INTERNATIONAL BUILDING CODE – GENERAL

G7-06/07, Part I

MAXIMUM BUILDING AREA – SINGLE OCCUPANCY
TYPES IIB, IIIB & VB CONSTRUCTION

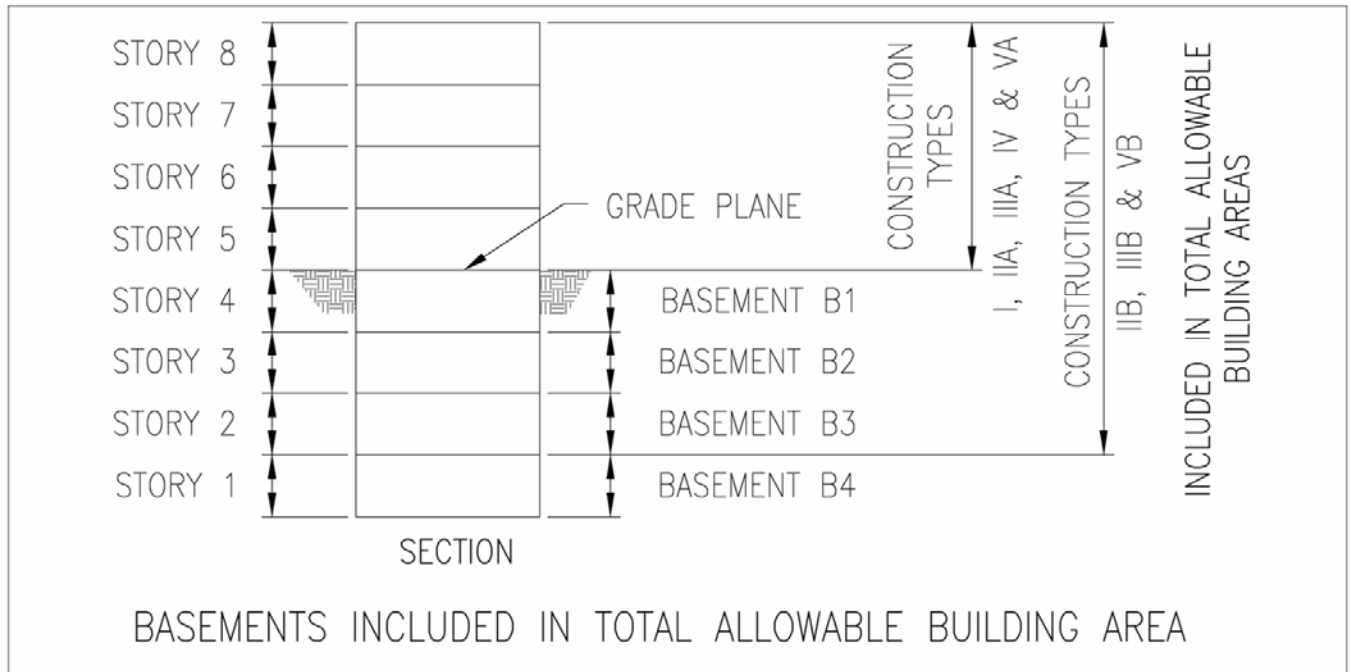
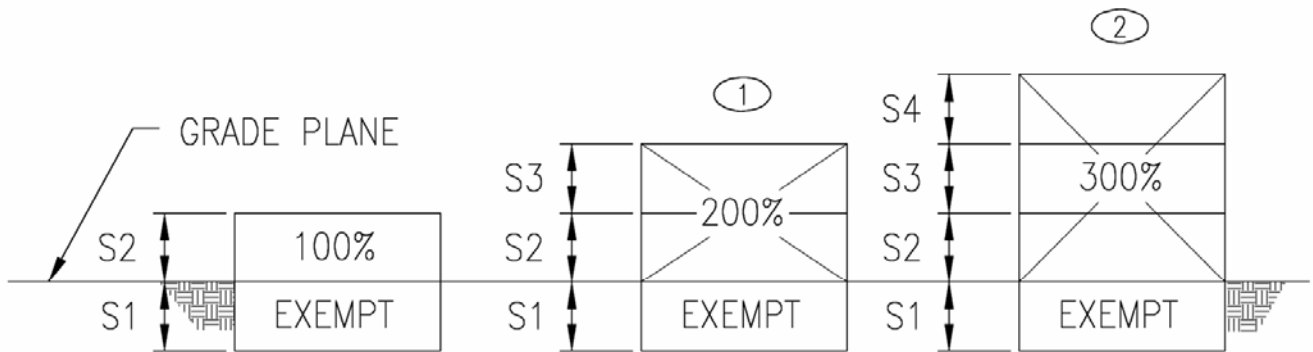
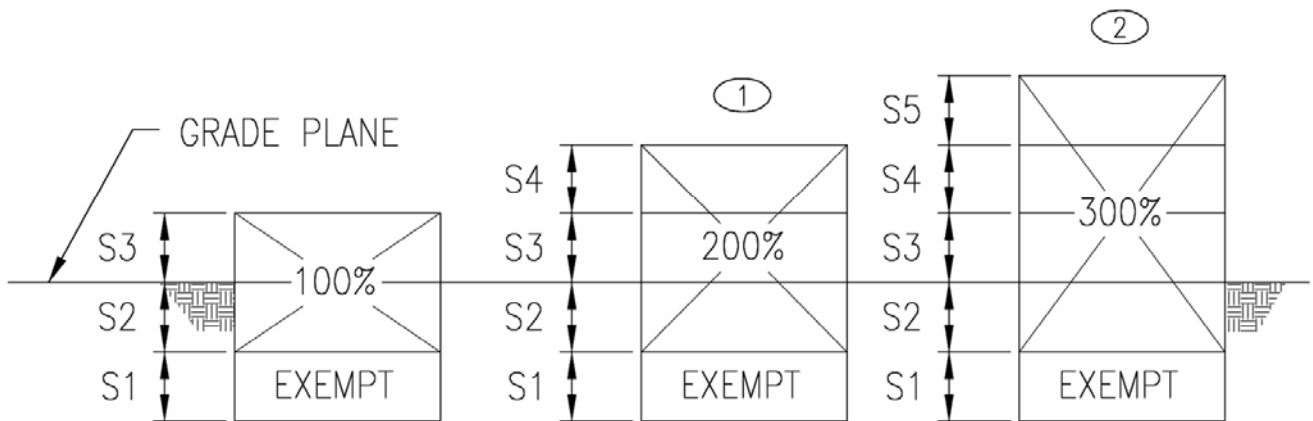
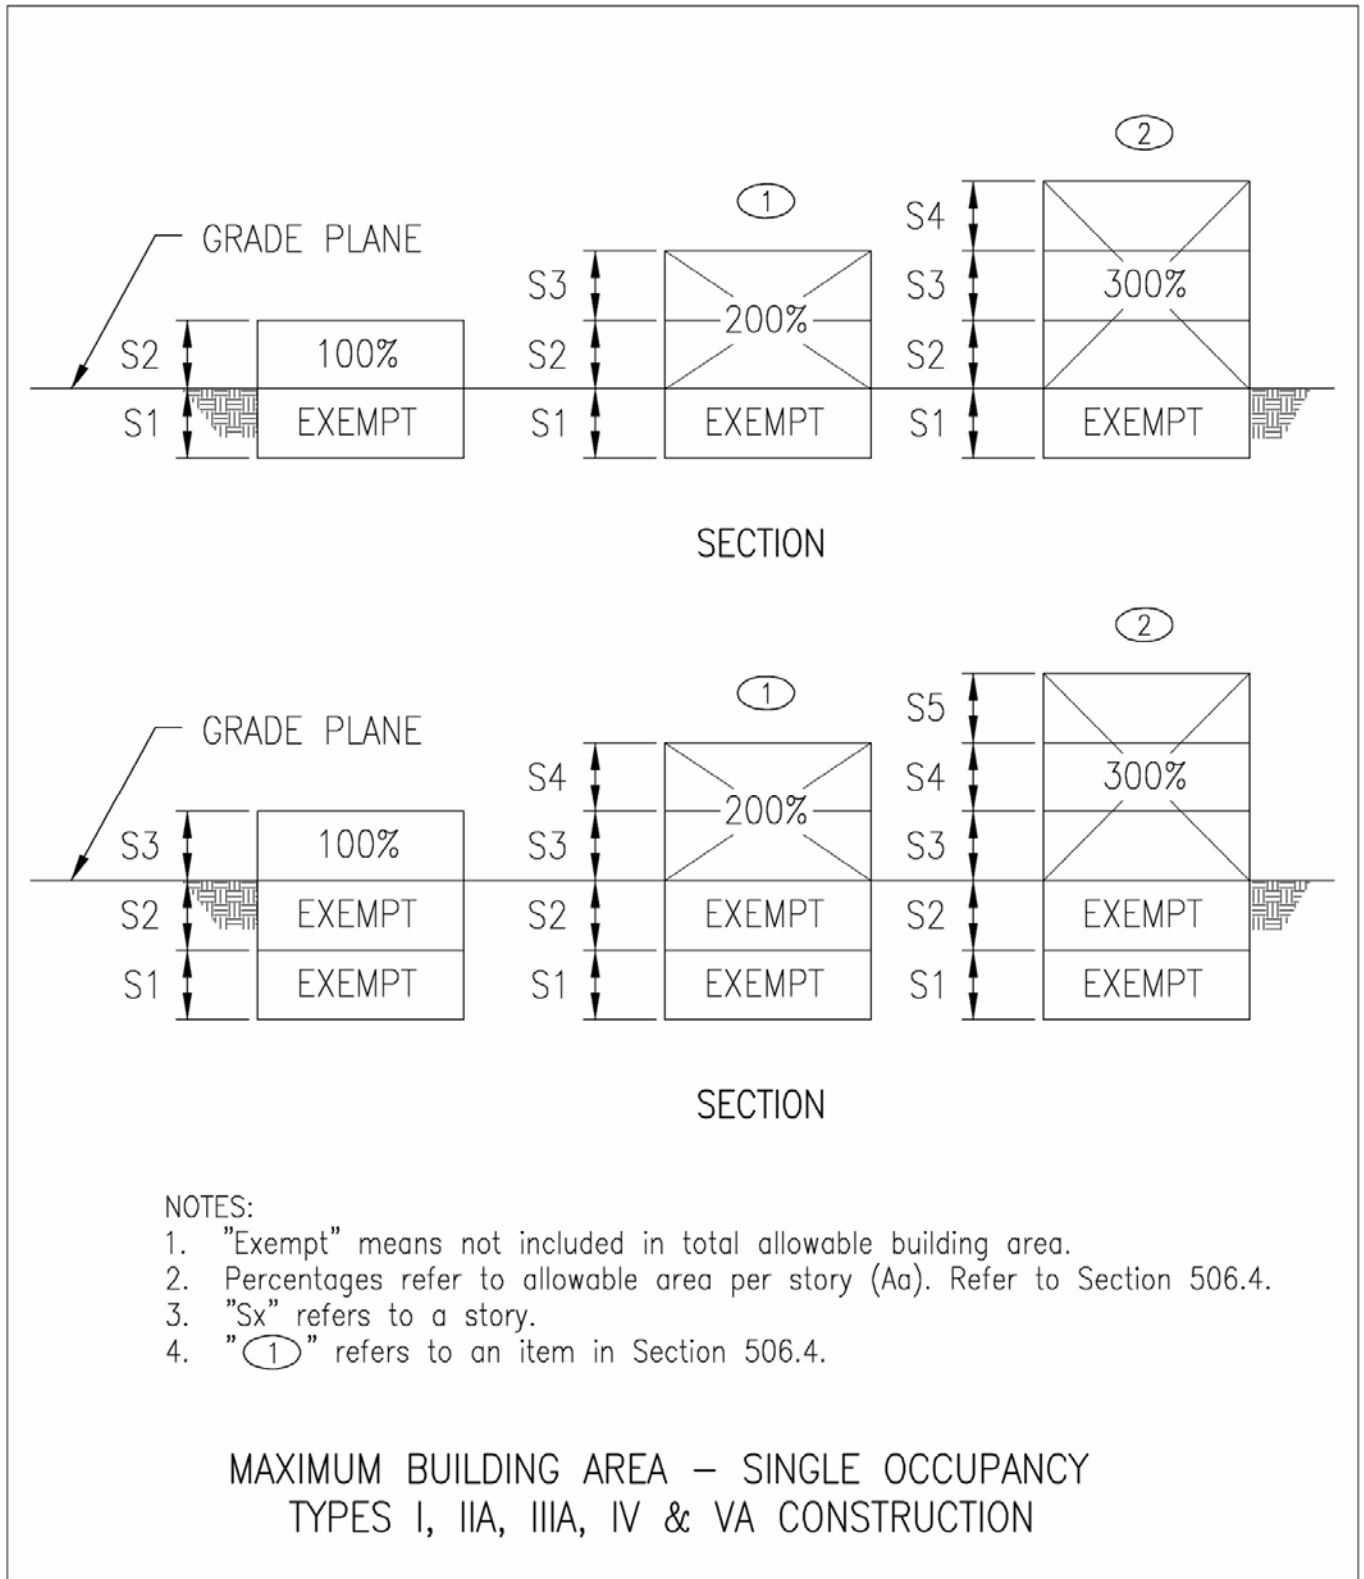
Consider the following example. Imagine a building that is eight stories in height. Grade plane is located at the upper surface of the floor at Story #5, which also places it at the upper surface of the floor above Story #4. Thus, there are four stories above grade plane (Stories #5 through #8) and four stories below grade plane (Stories #1 through #4). Stories #1 through #4 are completely below grade plane, which means that they are also basements. If a “single basement” is one story in height, the current language of Section 506.1.1 would exempt Story #1 from the total allowable area. The building would still have four stories above grade plane but the uppermost seven stories would be included in the determination of allowable building area. If a “single basement” includes all stories below the first story above grade plane that are also partly or completely below grade plane, the building would have four stories above grade plane but the uppermost four (not seven) stories would be included in the determination of allowable building area. I believe the second part of the example illustrates the basic intent of the IBC. The proposed modifications accomplish what the second part of the example illustrates. See the accompanying diagram for further information.

Three diagrams accompany this proposal. The first diagram illustrates the locations of the stories and basements described in the example above. It also specifies which basements would be included in the total allowable building area if the proposal is approved. The second and third diagrams illustrate how the determination of the maximum area of a building with more than one story above grade plane (Section 506.4) would be affected by the proposal. One diagram illustrates the affect on buildings of Type IIB, IIIB or VB construction. The other diagram illustrates the affect on buildings of Type I, IIA, IIIA, IV or VA construction.

506.1.1 Basements. A single basement that is not a story above grade plane need not be included in the total allowable building area, provided such basement does not exceed the area permitted for a building with no more than one story above grade plane.

Exception: In buildings of Type I, IIA, IIIA, IV or VA construction, the basements below the first story above grade plane need not be included in the total allowable building area provided each such basement does not exceed the area permitted for a building with no more than one story above grade plane.
